STAFF RECOMMENDATION 3616A Westbrook Avenue August 19, 2020

Application: New Construction—Infill
District: Richland-West End Neighborhood Conservation Zoning Overlay
Council District: 24
Map and Parcel Number: 104050436.00
Applicant: Julia Grissett
Project Lead: Jenny Warren, jenny.warren@nashville.gov

Description of Project: Application to construct a new single-family infill with an attached garage at basement level.

Figure 10. The proposed footprint and setback for the infill

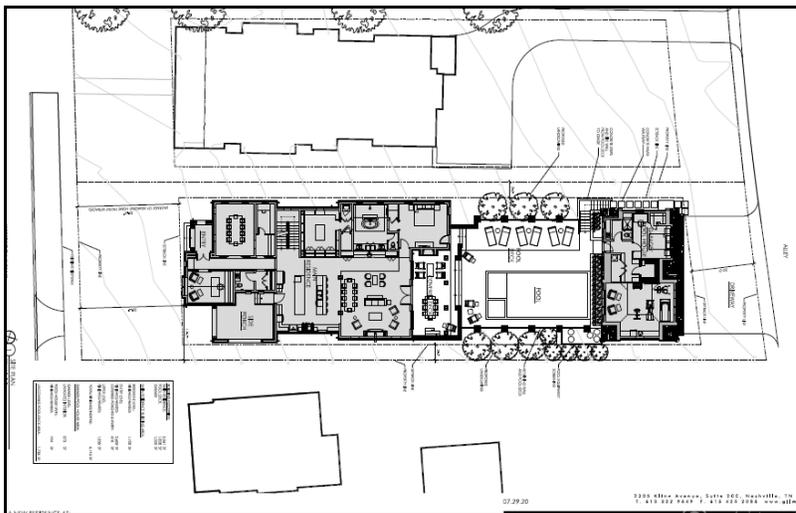
Setback & Rhythm of Spacing: The front setback is proposed to roughly align with the houses on either side. See Figure 10. The side and rear meet the standard five foot (5') and twenty foot (20') requirements, respectively.

Staff finds that the proposed setbacks to be similar to the immediate historic context and to meet Section II.B.1.c. of the design guidelines.

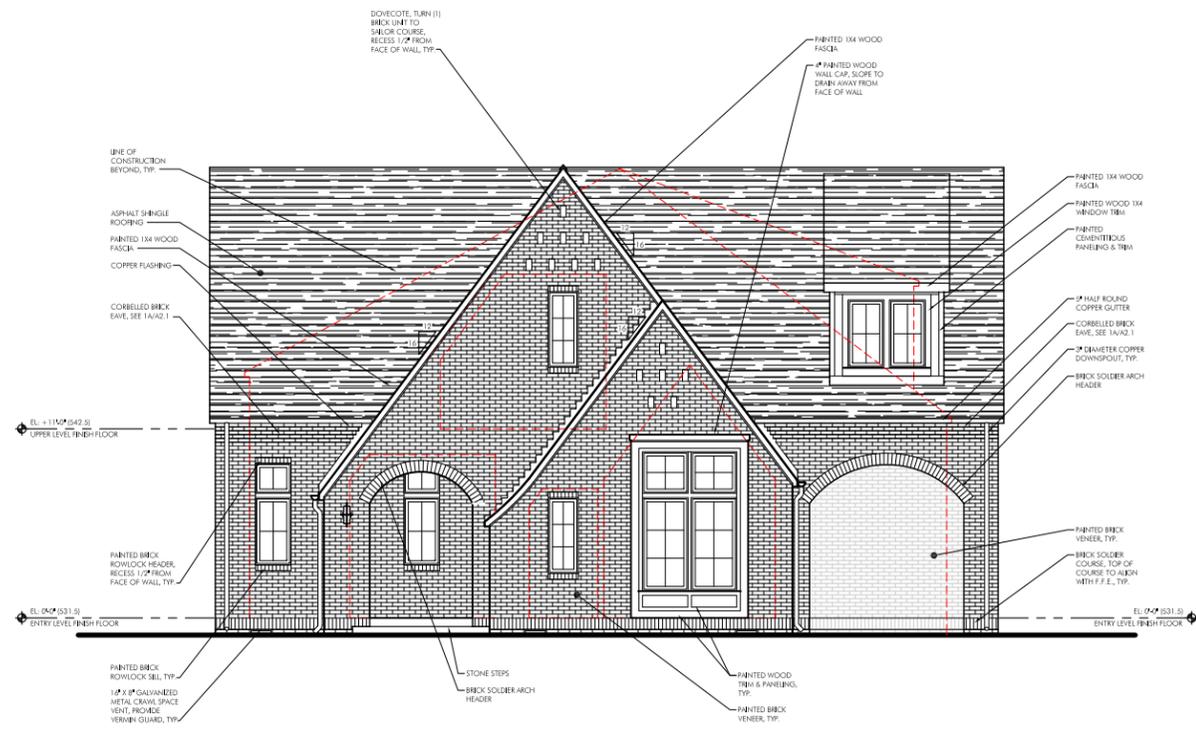
Attached garages are not a typical feature of this neighborhood. This garage is in the location of a historic garage, at the basement level and accessed on the rear, via the alley. The Commission has approved attached garages when they meet these requirements and

are fully connected to the rear of the house. However, in this case, the method of connection is via a fully enclosed hallway from the house. The floor plan is one long structure, creating exceptionally large massing and lot coverage. This form is not typical of an attached garage and is not appropriate to the context.

Staff recommends that the garage element be separated from the primary structure. The garage should meet all outbuilding requirements and should be separated from the primary structure by twenty feet (20') as per the design guidelines.

1 FRONT ELEVATION (SOUTH)
SCALE: 3/32" = 1' - 0"

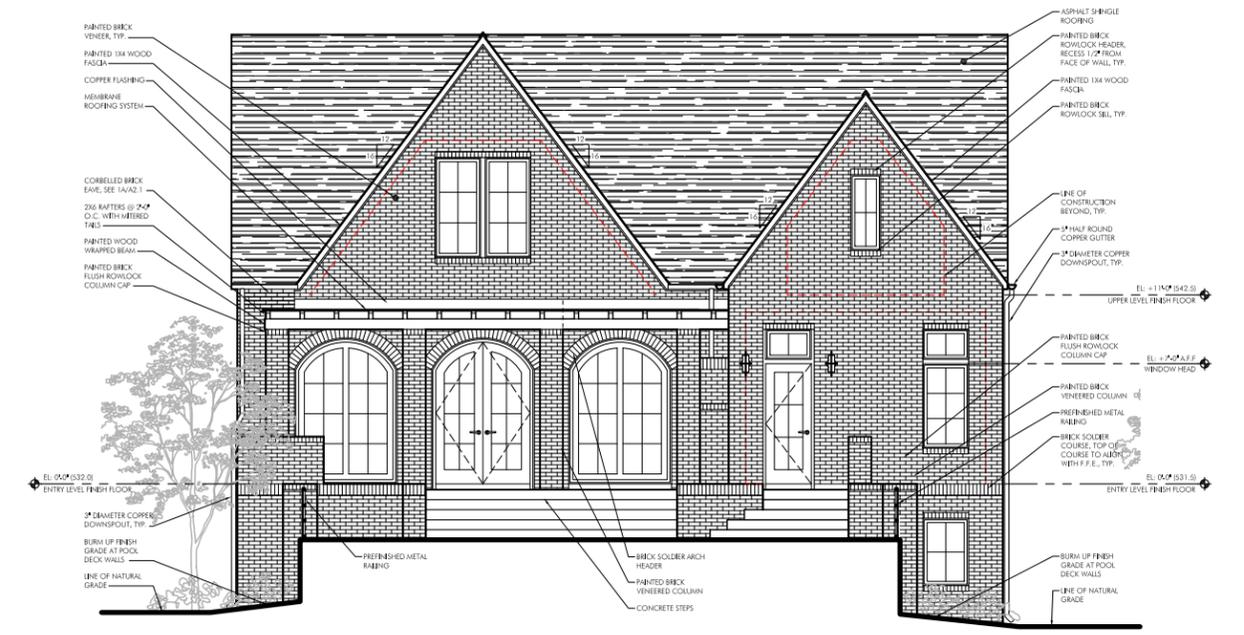
Height & Scale: The proposed infill will be one and a half stories and will have a maximum height of about twenty-seven feet, two inches (27'2") from front grade, with an eave height of approximately twelve feet (12'), above grade at the front. Staff finds that the proposed height is similar to the heights of historic houses in the immediate vicinity, which range from about seventeen to about thirty-two feet (17'-32') tall.

3 SIDE ELEVATION (EAST)
SCALE: 3/32" = 1' - 0"

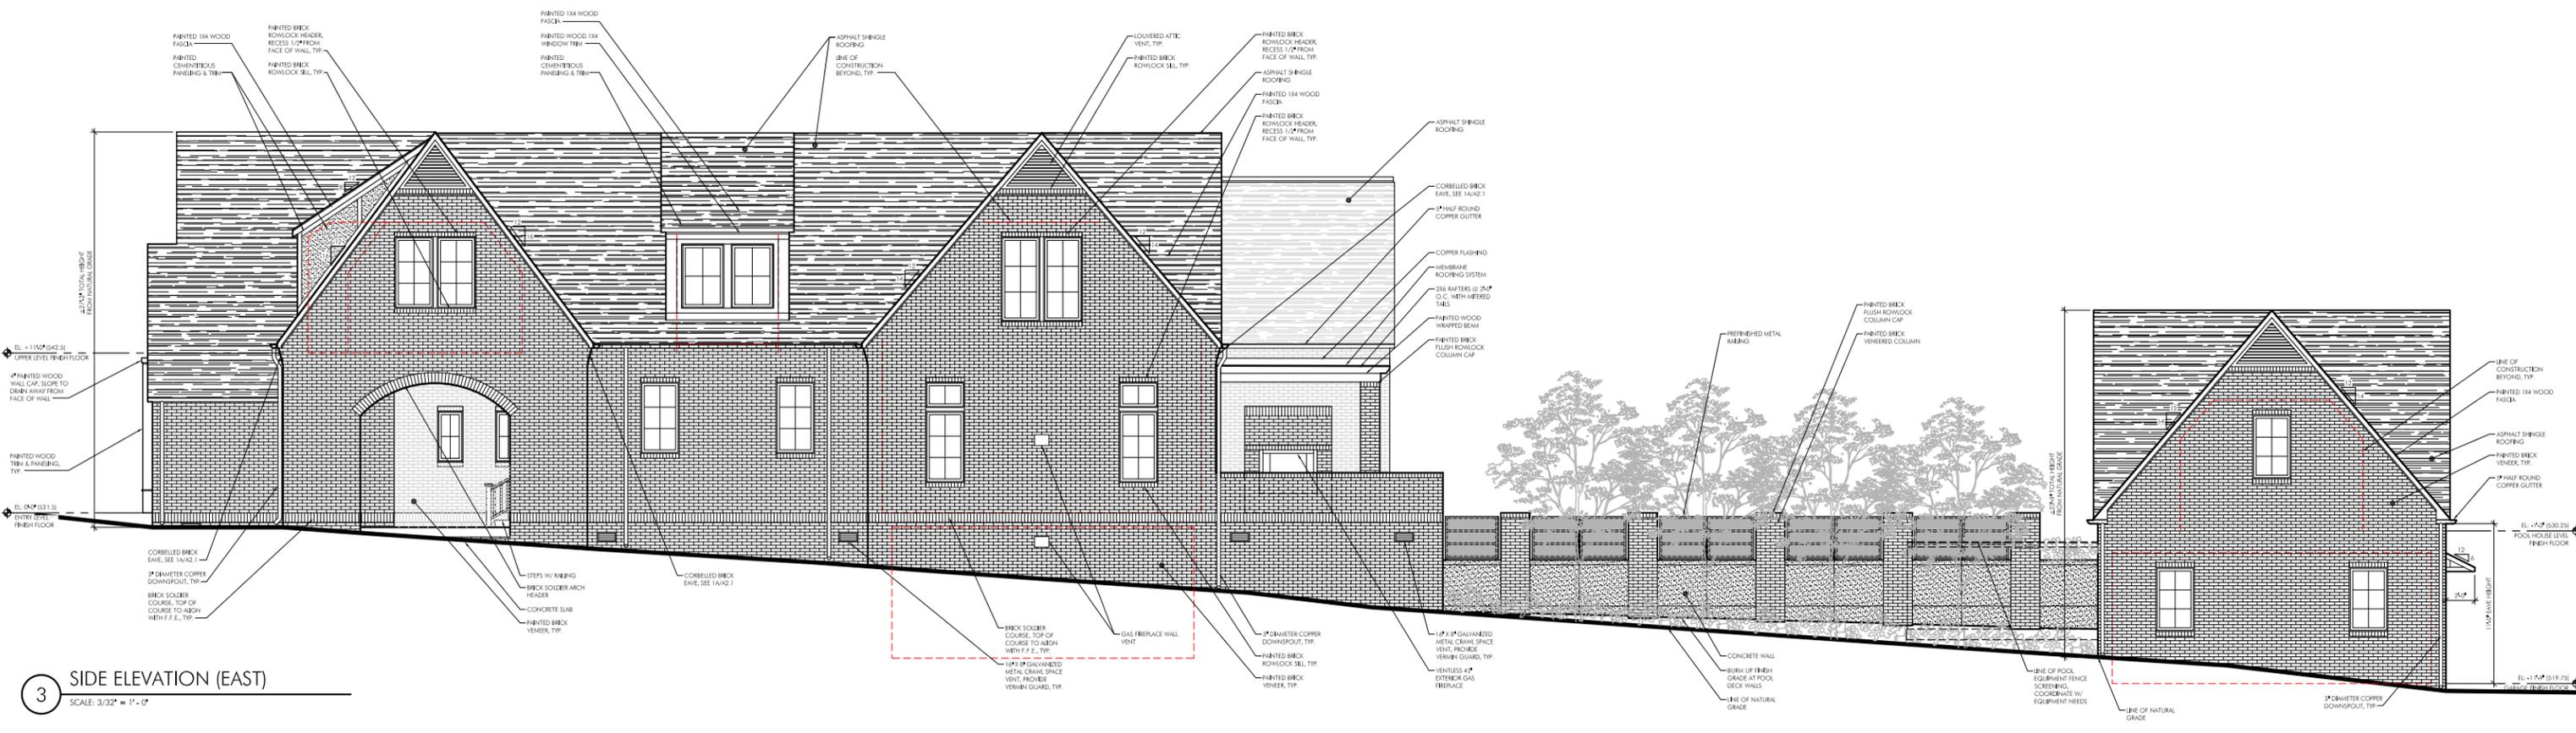
The foundation height will be about six inches (6") at the front of the house, but the grade drops approximately eleven feet, nine inches (11'9") by the rear wall of the garage. (Figure 3) Staff recommends inspection of the foundation and the finished floor height to ensure that the height of the foundation at the front is appropriate for the historic context.

3614- 3616B WESTBROOK AVENUE
BUILDING HEIGHTS

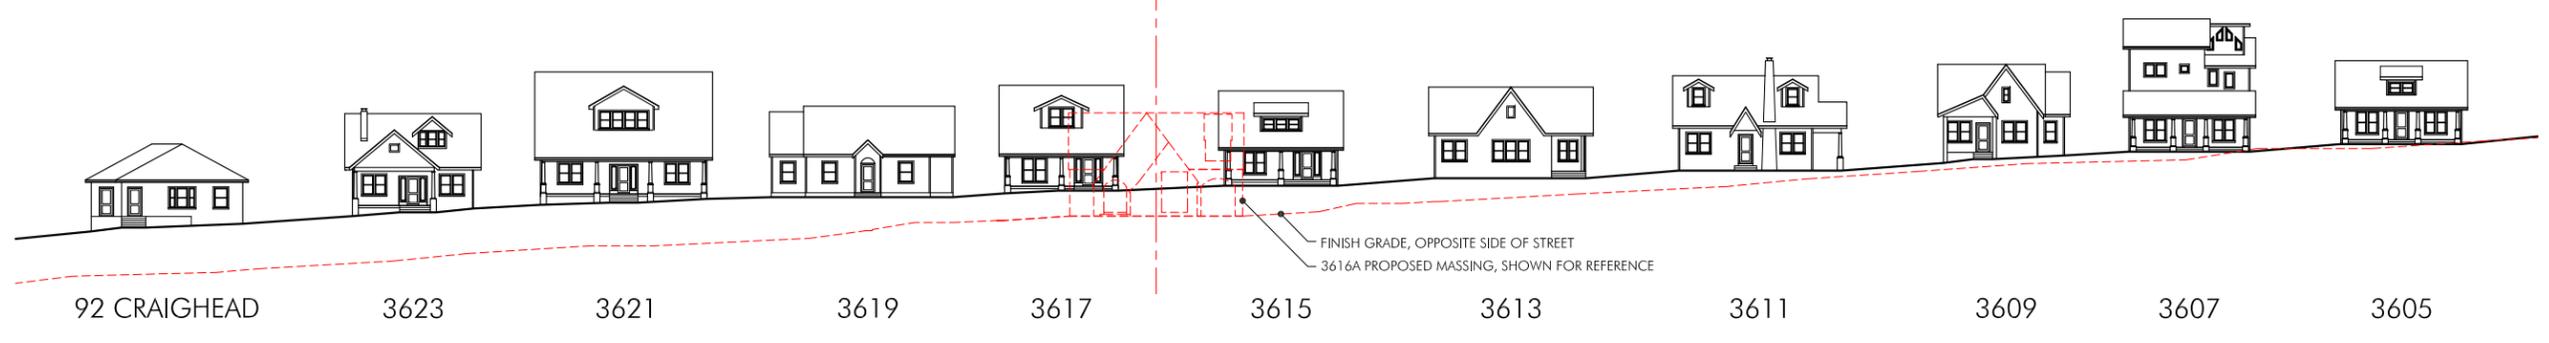
The lot is approximately fifty-seven feet, six inches (57'6") wide. The proposed house is approximately forty-five feet (45') wide at the front. Most of the houses on comparably sized lots are significantly narrower. The houses on either side are thirty-six feet (36') and thirty feet (30') wide. (Figure 4)

The widest house on the block is 3621 Westbrook, across the street and three houses down. This house is a bit of an outlier at thirty-two feet (32') tall and forty-four feet (44') wide and sits on a wider sixty foot (60') lot. Several other houses on the block measure forty or forty-one feet wide (40'-41'), but three of these include a one-story open porte cochere with no massing behind it. The actual building width on these is closer to thirty feet (30'). The front elevation of the proposed structure does have an open side porch, however, there is a second story above this and massing behind it. A one-story open side porch would be appropriate here as well, but with the second story above it, creating a continuous ridge line, and the depth of the massing behind it, creating a true forty-five foot (45') width, staff finds that the width is inappropriate. The only other house with a similar form in the immediate context is 3613 Westbrook (Figure 9), which sits on a much wider seventy foot (70') lot and is significantly shorter at about twenty-two feet (22') tall.

Given the proposed depth, a height which will make it the second tallest house on the block and a width that matches that of the widest historic house, staff finds the overall massing is too great for the historic context.

1 SITE PLAN
SCALE: 1/16" = 1'-0"

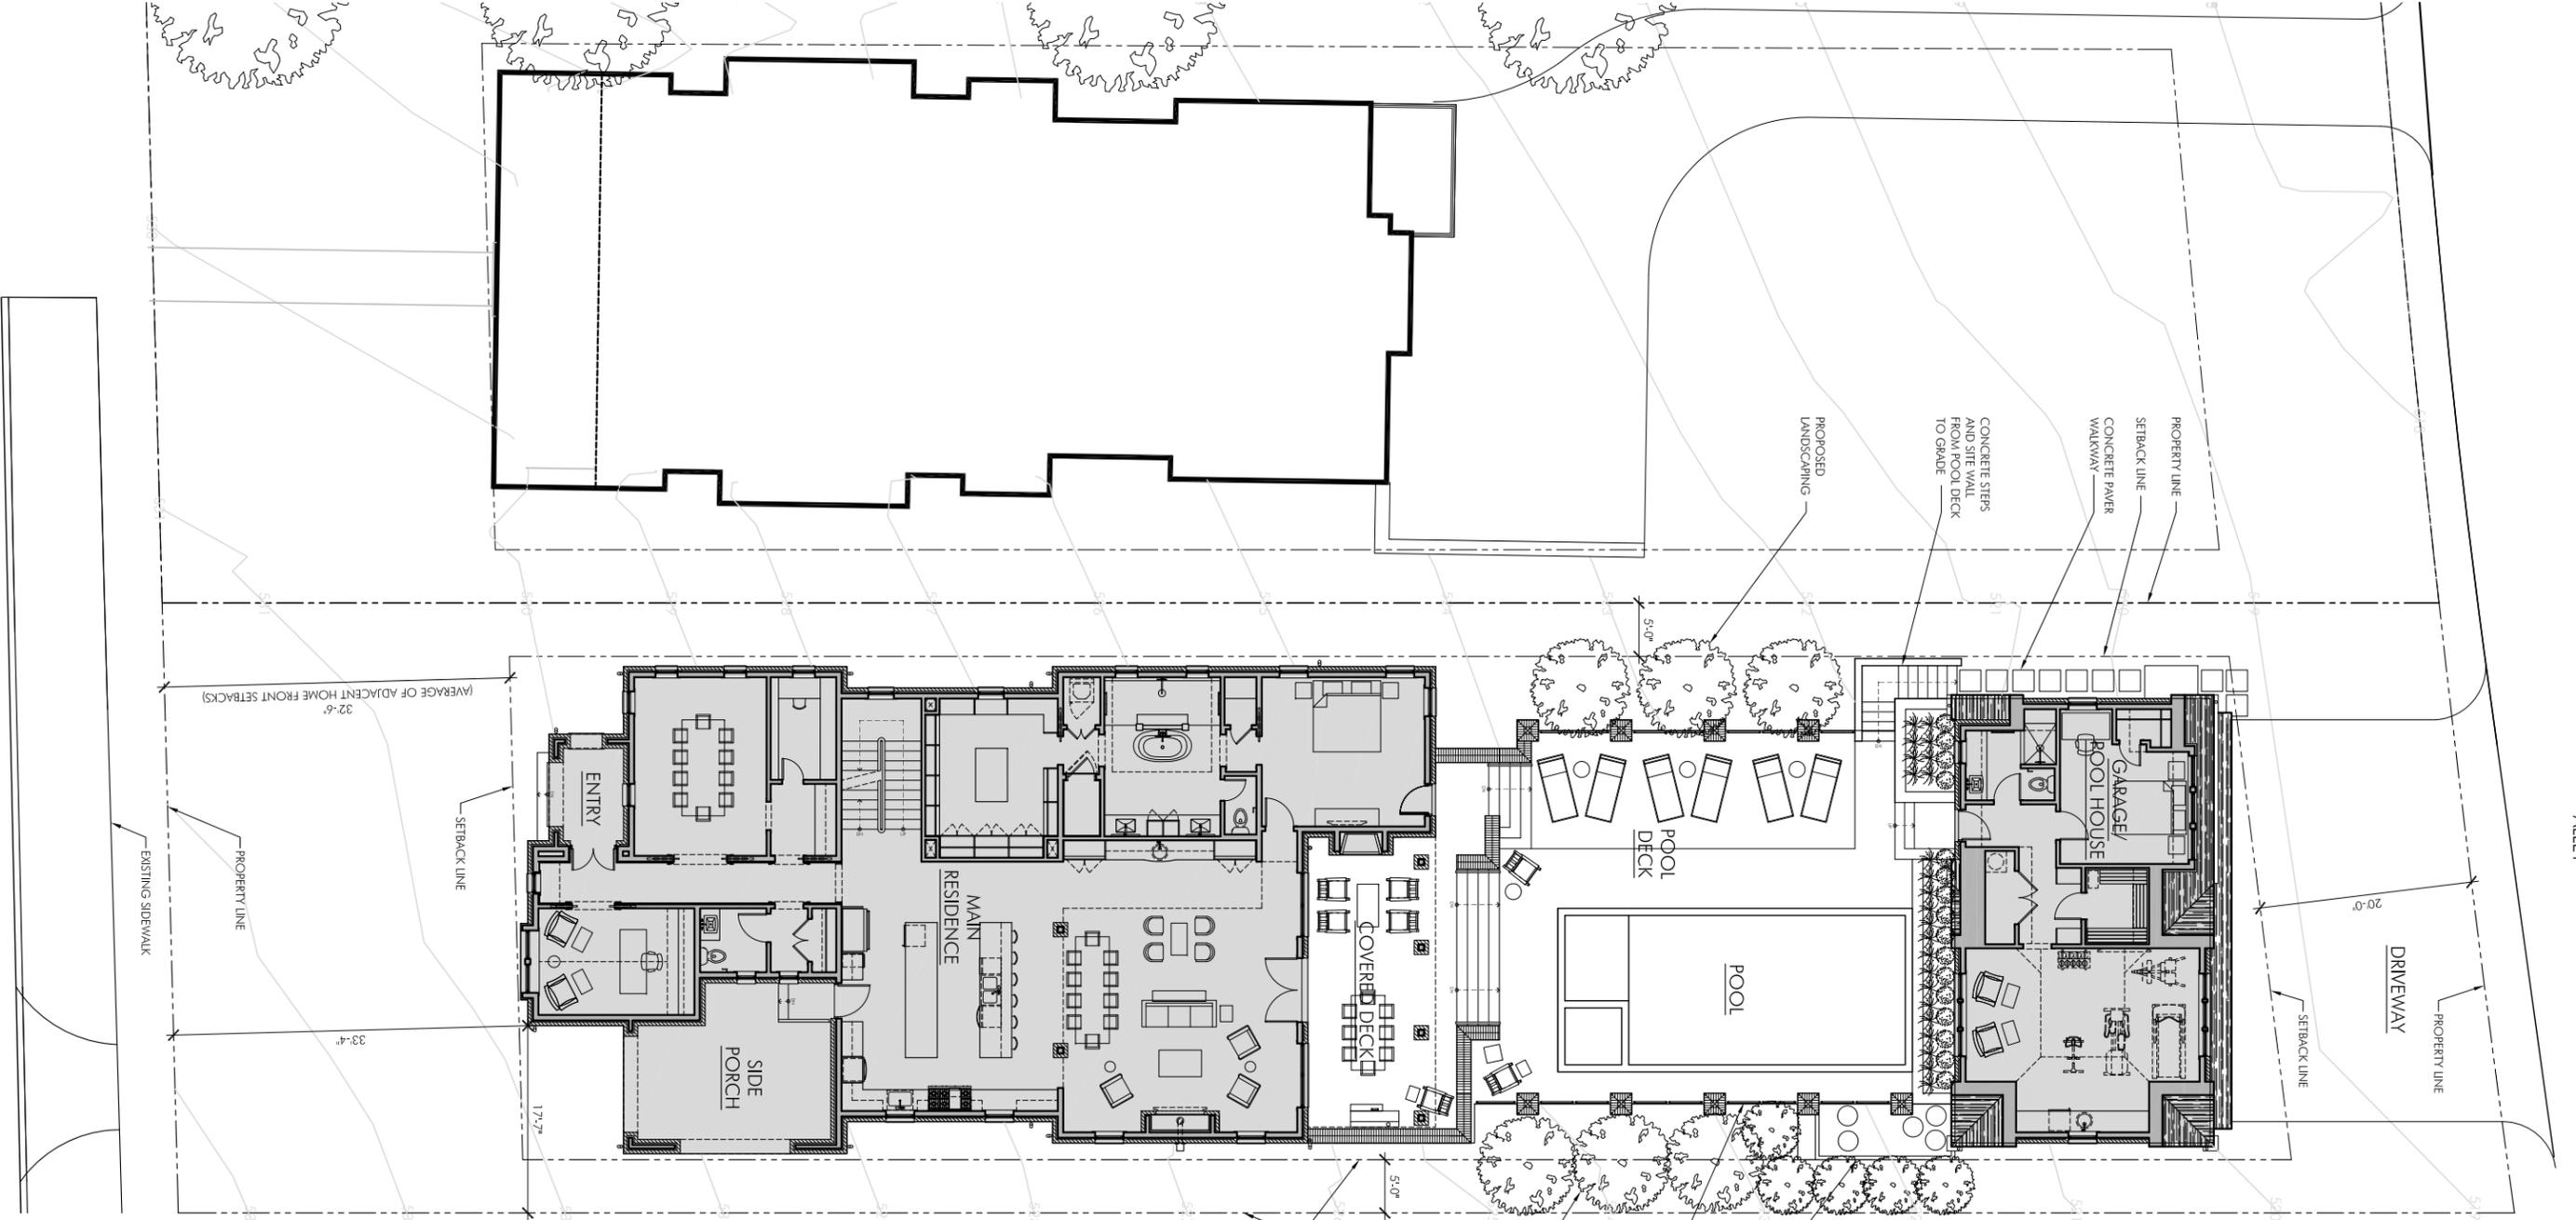
The house is also extremely deep. The one and one-half portion is about eighty-seven feet (87') deep, with the entire building stretching about one hundred and sixty feet (160'). The garage is connected to the primary house via a raised hallway underneath the pool deck. This connection creates one long footprint from front setback to rear setback.

Orientation: The house is oriented towards Westbrook Avenue, which is appropriate. There is a small covered entry porch and a more substantial side porch. Most historic houses in Richland-West End have partial or full-width porches. Rather than facing the street, the front door is perpendicular to the street, off the entry porch. This is a condition that is sometimes seen in historic houses, including right across the street at 3613 Westbrook (Figure 9). Staff finds it to be appropriate here. No walkway shows on the site plan: a front walkway should be added from the sidewalk to the entry porch.
